STRATA REPORT

Client	Andrew C. So
Address of property	Unit A603/2 Sunders Close, Macquarie Park, NSW.
Lot	62
Strata Plan	SP 89124
Name of Strata Management Co.	Bright & Duggan
Telephone Number of Strata Agent	9902 7100
Report Date	4 September 2023

Photo 5: Sheet metal catch drain fitted to construction joint between the ground floor slabs of buildings A and B on B1. This drain was found to be leaking.

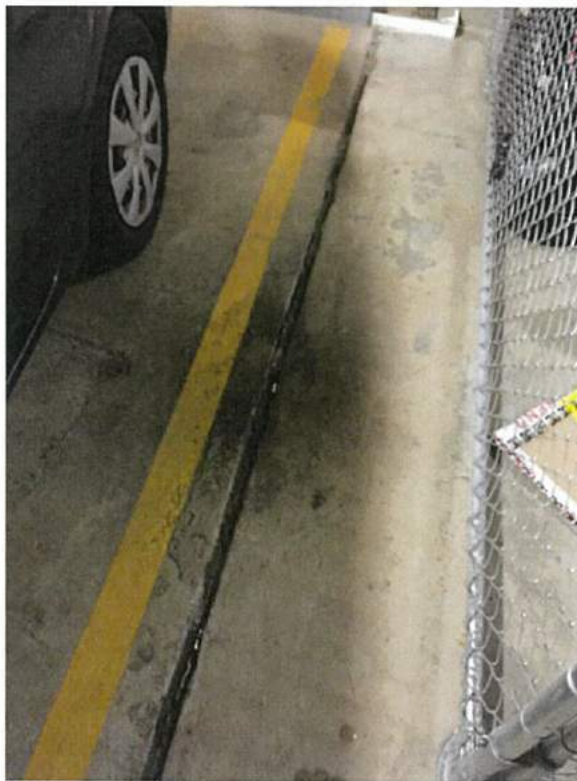
- 2.1.5 Photo 5 shows the sheet metal catch drain which has been fitted to the construction joint between buildings A and B on the soffit of the ground floor slab. The catch drain leaks and water was observed on the B1 slab below the catch drain as shown in Photo 6.

- 3.1.7 The sheet metal catch drain, fixed to both sides of the construction joint between buildings A and B has failed. It is my opinion that the solution as constructed is unable to accommodate the movement between the buildings. It is also my opinion that water entry into the basement should be prevented by the waterproofing of the construction joint above the ground floor slab.

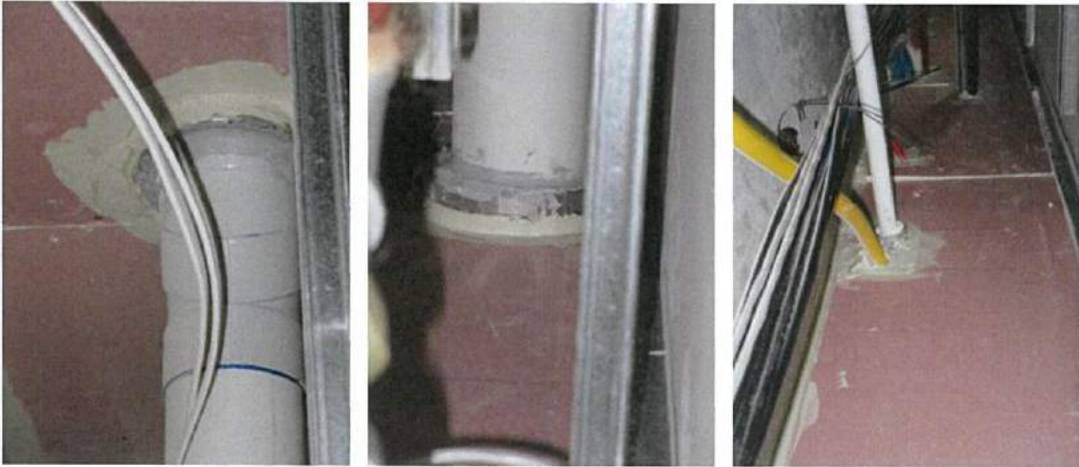
Item No.	Description and Location of the Defect	Agreed Scope of Works	BCA Logic Photograph	Defect Status and Photograph
30.	<p>General</p> <p>We observed electrical conduits and NBN conduits pipes throughout the foyer levels to have no fire collars installed.</p> <p>It is noted that in various instances the conduits have been sealed with a mastic.</p> <p>This was generally observed in the following locations:</p> <ul style="list-style-type: none"> - Ground Floor - Level 1 - Level 2 - Level 3 - Level 5 - Level 6 - Level 7 - Level 8 - Level 9 - Level 10 - Level 11 - Level 12 - Ground Floor – within riser into U3 - Ground Floor – within riser into slab above - Level 3 – U302 - Level 5 – NBN Cupboard x5 through bounding wall - Level 6 – NBN Cupboard x5 through bounding wall - Level 7– NBN Cupboard x5 through bounding wall - Level 8– NBN Cupboard x5 through bounding wall 	<p>1. Supply and install an approved fire collar such as a Promat conduit collar to the conduit penetrations on both sides of the wall in accordance with the manufacturers recommendations to maintain the FRL.</p>		<p>Toga propose to use two Promat CFC 32 Uni Collars joined together.</p> <p>Methodology yet to be provided.</p> <p>Test Report Number A-12-163d</p>

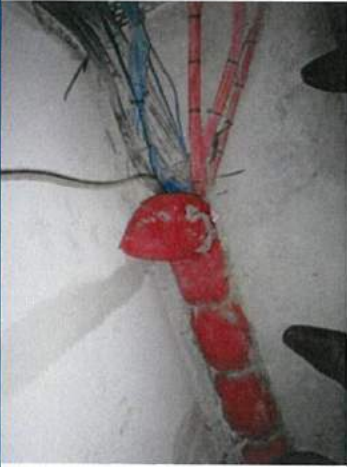
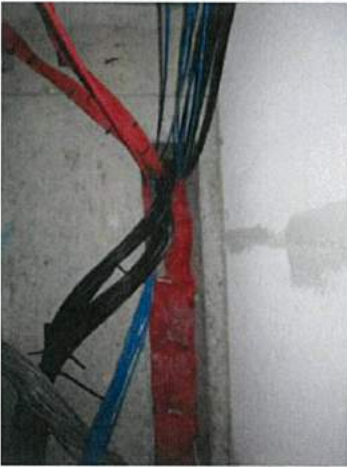
34.	<p>Smoke Doors</p> <p>The corridors to all levels are measured to be greater than 40m. Therefore smoke doors are required.</p> <p>We noted that the smoke doors have gaps evident when in the closed position on the following Levels:</p> <ul style="list-style-type: none"> - Ground Floor - Level 1 - Level 5 	<ol style="list-style-type: none"> 1. Adjust the existing doors to ensure that they are fully operable and close simultaneously in the correct position to prevent the free passage of smoke. 2. Remove all existing smoke seals. 3. Supply and install a fully compliant smoke seal system such as a <i>Lorrient</i> smoke seals in accordance with the manufacturer's recommendations suitable for the gaps within the smoke doors. 		<p>Toga to adjust seals to prevent free passage of smoke.</p>

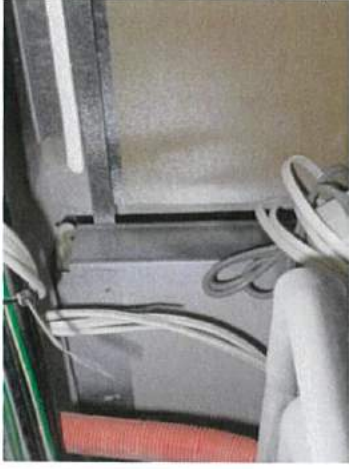
Item No.	Description and Location of the Defect	Agreed Scope of Works	BCA Logic Photograph	Defect Status and Photograph
42.	<p>Electrical/Communications cupboard</p> <p>We identified a number of unsealed electrical, communications and data cables penetrating through the bounding walls of the adjoining units.</p> <p>There were a number of redundant penetrations through the bounding walls.</p> <p>This was observed in the following locations:</p> <ul style="list-style-type: none">- Ground Floor – x2 cables- Level 1 – unsealed void- Level 2- Level 3- Level 5- Level 6- Level 7- Level 8- Level 9 – x1 cable- Level 9 – x1 redundant- Level 10- Level 11 – x2 cables- Level 12	<ol style="list-style-type: none">1. Appropriately seal around the electrical/communications/data cable(s) and any redundant penetration with a fire rated mastic in strict accordance with the manufacturer's recommendations.2. Where there is an excessive sized penetration or oversized redundant penetration, supply and install an approved Magnesium silicate board (Such as Trafalgar Maxilite system) around the penetration and secure to the wall in accordance with the manufacturers recommendations.	 	<p>Toga to reseal with Promat Promaseal AN Acrylic Sealant</p> <p>Test Report A-13-816</p>

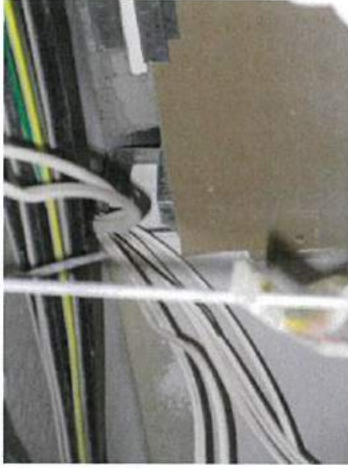
44.	<p>NBN Cupboard</p> <p>Electrical cables and conduit located half within the corridor and half within adjacent Unit bounding wall. This was observed in the following locations:</p> <ul style="list-style-type: none"> - Level 2 - Level 3 - Level 5 - Level 6 - Level 7 - Level 8 - Level 9 - Level 10 - Level 11 - Level 12 	<ol style="list-style-type: none"> Box out the electrical conduit with an approved two way fire rated system such as Trafalgar Maxilite board to maintain an FRL of -/60/60. Supply and install a new retro-fit conduit collar to electrical conduit in strict accordance with the manufacturer's recommendations. 		<p>Toga propose to surround the penetration with a fire rated board and install a Promat Uni collar.</p> <p>Methodology and materials yet to be provided.</p>

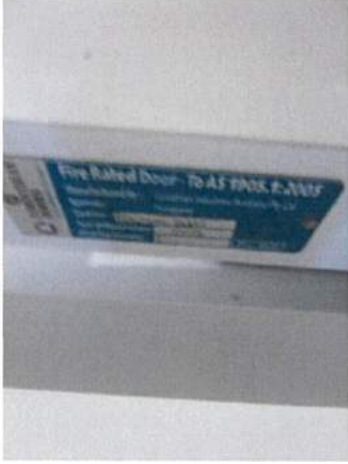
61.	Level 11 – NBN Cupboard There are x2 plastic water pipes penetrating through the bounding wall of Unit 1101 with no fire collar installed.	1. Gain access into the ceiling space as required. 2. Supply and fix an approved retrofit fire collar suitable for plastic pipework in accordance with the manufacturers recommendations.		Toga propose to use two Promat CFC 32 Uni Collars joined together. Methodology yet to be provided. Test Report Number A-12-163d

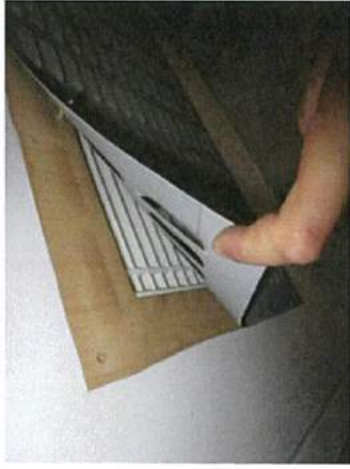
Item No.	Description and Location of the Defect	Agreed Scope of Works	BCA Logic Photograph	Defect Status and Photograph
67.	<p>Ground floor – Garbage room</p> <p>There are various copper pipes penetrating through the floor slabs with no fire stopping.</p> <p>There are a number of pipes located in 100mm slab block outs with no protection.</p> <p>There were approximately 6 instances within the garbage room.</p>	<ol style="list-style-type: none"> Where the penetration is too large, surround the PVC with a tight fitting calcium silicate board (such as Trafalgar Maxilite board, or equivalent) so that the entire opening in the wall is covered with an overlap of not less than 100mm. Fix and seal to maintain a FRL of not less than 2 hours. Seal between the pipe and the board with an acrylic fire rated sealant (such as Trafalgar Fyreflex, or equivalent). 	 	<p>Toga will surround the oversized penetration with a fire rated board.</p> <p>Toga to reseal with Promat Promaseal AN Acrylic Sealant</p> <p>Test Report A-13-816</p>

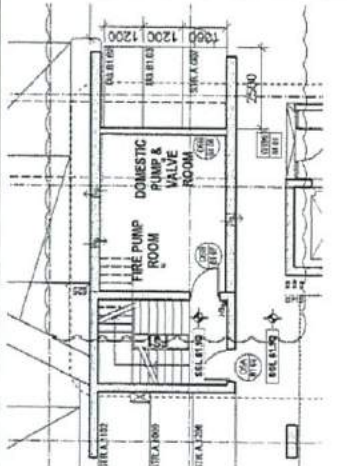
Item No.	Description and Location of the Defect	Agreed Scope of Works	BCA Logic Photograph	Defect Status and Photograph
101.	<p>Basement Carpark – Level 1</p> <p>There are a number of Hydrant pipes penetrating through the floor slabs with no fire stopping.</p> <p>This was observed in the following locations:</p> <ul style="list-style-type: none">- C2 1207 – x1- C2	<p>1. Seal between the pipe and the slab with an approved fire rated sealant in accordance with the manufacturer's recommendations.</p>		<p>Toga to reseal with Promat Promaseal AN Acrylic Sealant</p> <p>Test Report A-13-816</p>
